ST ASAPH STREET

POST CONSTRUCTION ROAD SAFETY AUDIT

Prepared for Christchurch City Council

13 March 2017

Photo 13: Example of RRPM loss

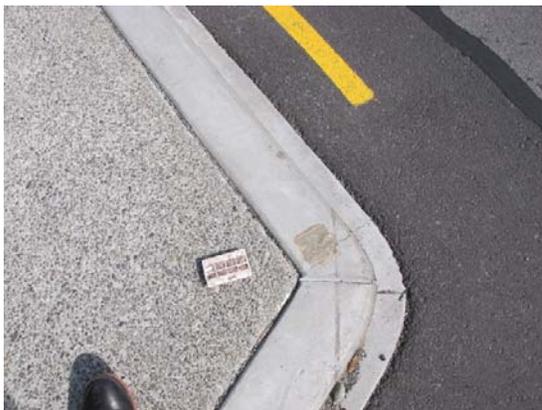
Of concern to the SAT was the high proportion of RRPM's that were absent – evident by the adhesion marks on the kerb top. This would indicate that the attachment adhesive utilised has failed under general use, and the effect of vehicles running over the low profile kerb to access car parks or driving into access ways. This overrun gets worse as more units are knocked off, resulting in a higher level of impacts onto the units, resulting in a greater level of loss.

Figure 2-3: Design Drawing of intersection.

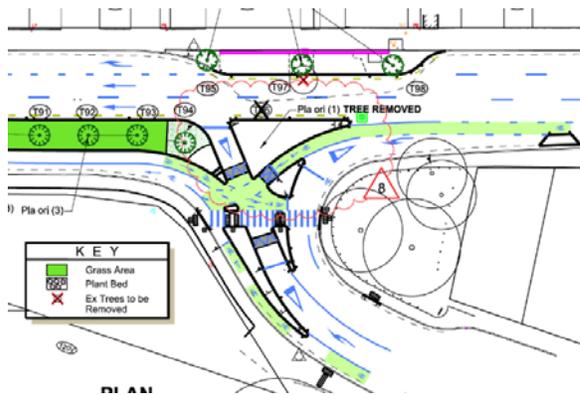
A review of the supplied plans indicate that the Detailed Design approved (refer to Figure 2-3) has the westbound (St Asaph) cyclist having to give way to the eastbound cyclist movement.

The design drawing shows a large area of green surfacing covering the whole conflict zone at the Ferry Road intersection. It was observed that the green markings are confined to the path of the cycle lane only, reducing the effectiveness that total coverage would provide.

Cyclists are approaching the intersection at generally 20km/h to 30km/h, however the markings (and signage) is reasonably complex and difficult to interpret when travelling at these speeds, especially when changing direction, and potentially giving way to other cyclists, motorists and pedestrians.
